<b>DR 100e</b>	Type 6012	No. 47
<b>DR 100s</b>	Type 6013	No. 46
<b>DR 400</b>	Type 5520	No. 165
<b>DR 600</b>	Type 5530/100	No. 210
<b>DR 800</b>	Type 6010	No. 55
<b>DR Retrofit</b>	Type 5400	No. 131
<b>DX-D 100</b>	Type 5410	No. 137
<b>DX-D 100 Wireless</b>	Type 5411	No. 186
<b>DX-D 300</b>	Type 8207	No. 170
<b>DX-D 400</b>	Type 5420	No. 125
<b>DX-D 600</b>	Type 5430	No. 191
<b>Valory</b>	Type 5540	No. 09

Document ID: 79488020

## Service Bulletin

### Service Quality Test Tool version 2.2 released

Figure 3

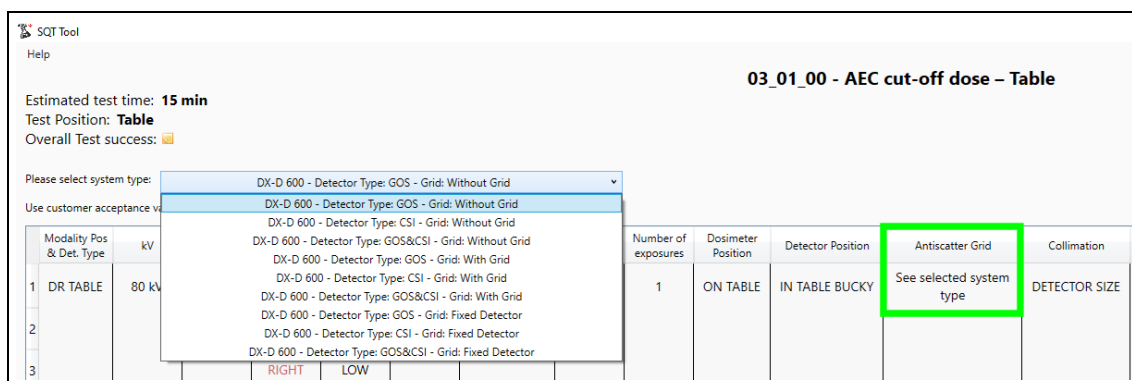
### 1.1.3 SQT test 3.1 (AEC cut-off dose) for DX-D 300, DX-D 400, DX-D 600: Unclear instructions with respect to antiscatter grid [PRB2000674]

**Symptom** In SQT test 3.1 (AEC cut-off dose) for DX-D 300, DX-D 400 and DX-D 600, it is possible to select whether an antiscatter grid is present or not. However, when selecting "Without Grid", the SQT 3.1 setup instructions still indicate that the antiscatter grid should be inserted.

**Solution** In SQT 2.2 test 3.1 for DX-D 300, DX-D 400 and DX-D 600, a reference is made to the “system type” selection to resolve the ambiguity.

### 1.1.5 SQT Test 5.1 (Sensitivity DR Detector) for XD Detector fails frequently [PRB2000723]

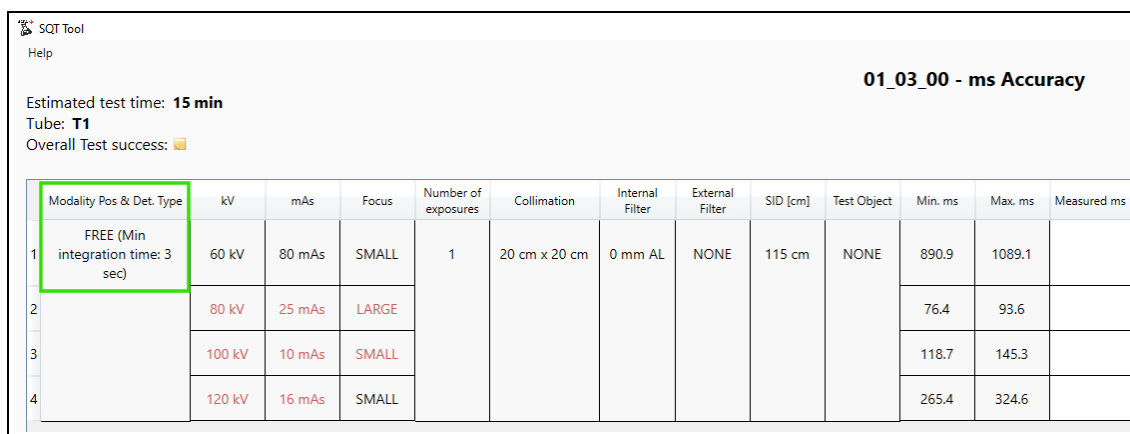
**Symptom** For some DX-D 40 and XD Detectors the SQT test “5.1 Sensitivity DR Detector” fails. Also the EI (Exposure Index) test fails, which is performed in some countries.

1. SQT test 5.1 limit values not optimal for XD Detectors.
2. Correction factor for sensitivity not optimal for XD Detectors, resulting in too large deviation in Exposure Index reading by NX.

**Solution** Part 1: SQT 2.2 contains updated PVI 5 min. / max. values. Refer to the table below.  
Part 2: VDI 4.1 contains updated Detector model files with optimized correction factor for sensitivity. For details refer to VDI 4.1 release SB with Document ID [77994774](#).

Detector	Old PVI 5 min	Old PVI 5 max	New PVI 5 min	New PVI 5 max
XD 10/14/17	44900	47300	43316	47203
XD*10/14/17	46200	48600	45220	49155
